Regulation No. 34 (Prevention of fire risks)**Proposal for the 03 series of amendments to Regulation
No. 34 (Prevention of fire risks)****Submitted by the expert from Japan***

The text reproduced below was prepared by the expert from Japan to amend the requirements for fire prevention under certain conditions in the event of a rear collision. This document is based on informal document GRSG-103-07 distributed during the 103rd session of the Working Party on General Safety Provisions (GRSG). The modifications to the existing text of the Regulation are marked in bold characters.

"Model B

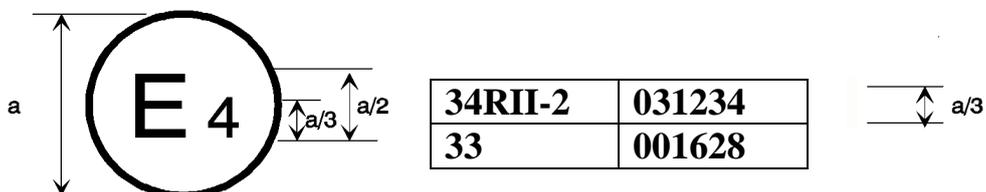
Annex 2, Model B, amend to read:

The above approval mark affixed to a vehicle shows that the type concerned was approved in the Netherlands (E4) pursuant to Regulations Nos. 34 Parts I or IV and II-1 and 33*/. The approval numbers indicated that, at the date when the respective approvals were given, Regulation No. 34 included the 03 series of amendments and Regulation No. 33 was still in its original form.

The above approval mark affixed to a vehicle shows that the type concerned was approved in the Netherlands (E4) pursuant to Regulations Nos. 34 Parts I or IV and II-2 and 33*/. The approval numbers indicated that, at the date when the respective

5. Ad paragraph 3.1.4.2. and Annex 2, Model B: Japan proposes to amend the approval number provisions and approval mark models on the basis of the same justifications as that of paragraph 1.2. above.

Fire incidence rate of rear-end collisions (Japan)

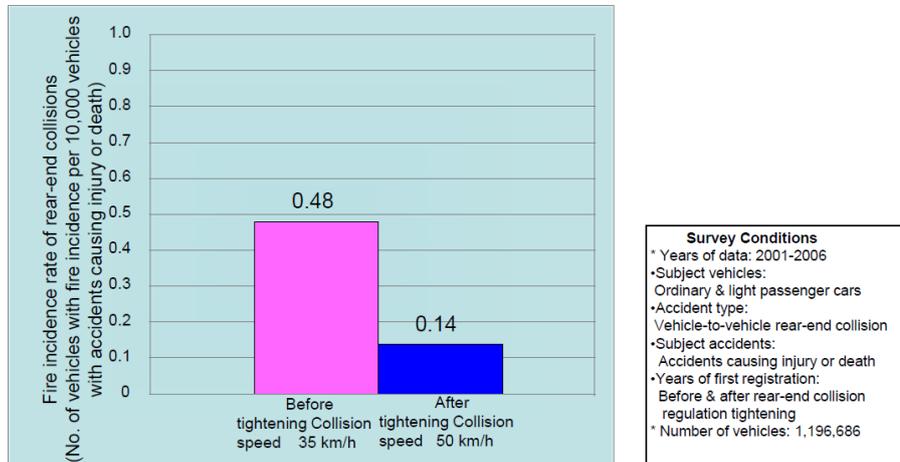
2. Japan has established standards for fire prevention in the event of a rear collision mandatory for passenger cars. The collision speed had been 35 km/h in the original standards, but was raised in 1993 to 48 to 52 km/h. The following chart compares the fire incidence rates of rear-end collisions before and after the raising of the collision speed. Since the fire incidence rate in rear-end collisions has been reduced by one-third after the introduction in the legislation of the increased collision speed, Japan proposes that the regulatory measure resulted in an effective safety enhancement of vehicles (see figure below).

After the tightening of the rear-end collision regulation (increased collision speed from 35 km/h to 50 km/h), the fire incidence rate of rear-end collisions has been reduced by about one-third, indicating that the regulatory tightening is effective.
